SERVICE BULLETIN

APPLICABILITY: 2020-25MY Legacy & Outback
2023-26MY Ascent

NUMBER: 07-213-22R

SUBJECT: Genuine Battery Replacement

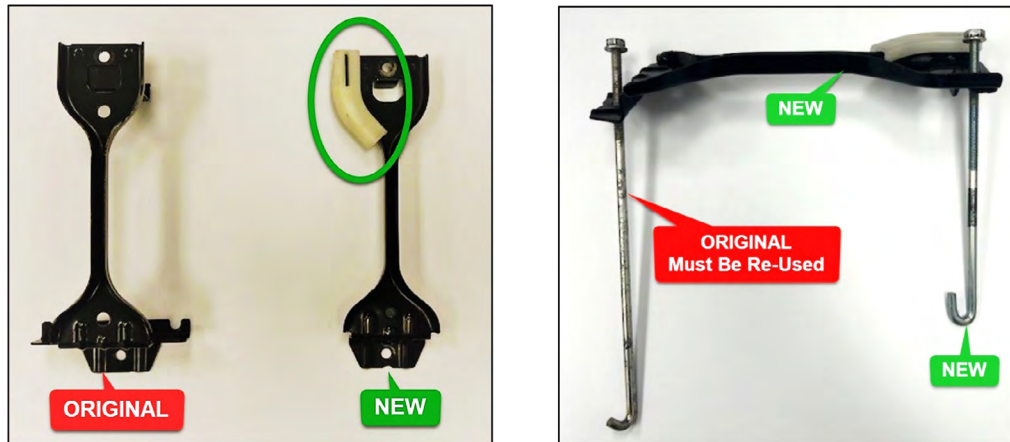
STEP 3: Replace the original battery tray with the new part (p.n. 82190AN000).
